# Rezoning Transportation Analysis

Petition Number: #2022-099

## Revision Log:

Date	Description
11-28-22	First Review (IW)
12-22-22	Second Review (IW)
01-26-23	Third Review (IW)
10-25-23	Fourth Review (NK)

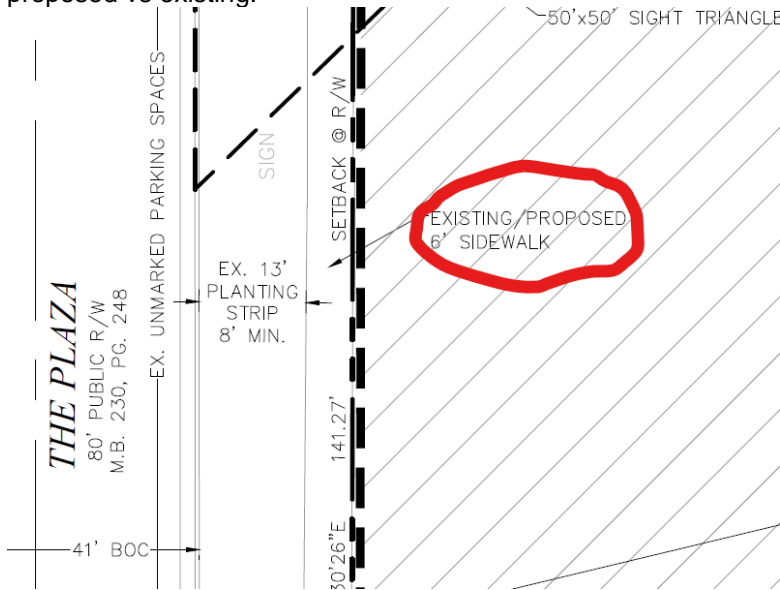
3. ~~**Outstanding Comment from 11-28-22: Comprehensive Transportation Review (CTR):**~~

~~The Comprehensive Transportation Review was recently approved by City Council under the new UDO. In lieu of a TTM for the proposed site CDOT has requested the petitioner complete a CTR for the site. The petition's zoning falls within the medium to high intensity development which based on the 1,775 daily trips will trigger Tier 3 (14 mitigation points) for multimodal assessment and Tier 3 (6 mitigation points) for transportation demand management assessment.~~

~~The petitioner shall review and assess the publicly accessible pedestrian network within ¼ mile walking distance of the site to identify multimodal infrastructure to meet the Tier 3 (14 mitigation points) for multimodal assessment. Petitioner shall also provide transportation demand management strategies to meet Tier 3 (6 mitigation points) to reduce vehicle trips and encourage alternative modes of transportation.~~

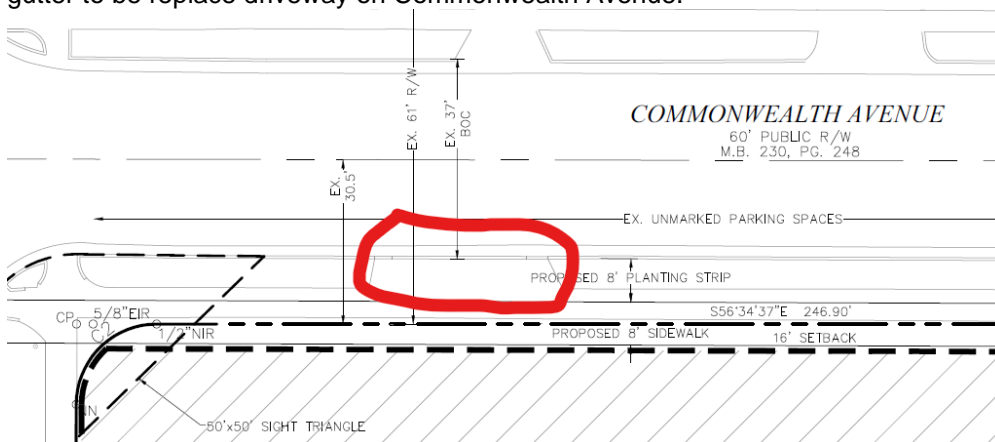
5. ~~Revise site plan and conditional note(s) to specify what portion of the sidewalk along The Plaza will be proposed vs existing.~~
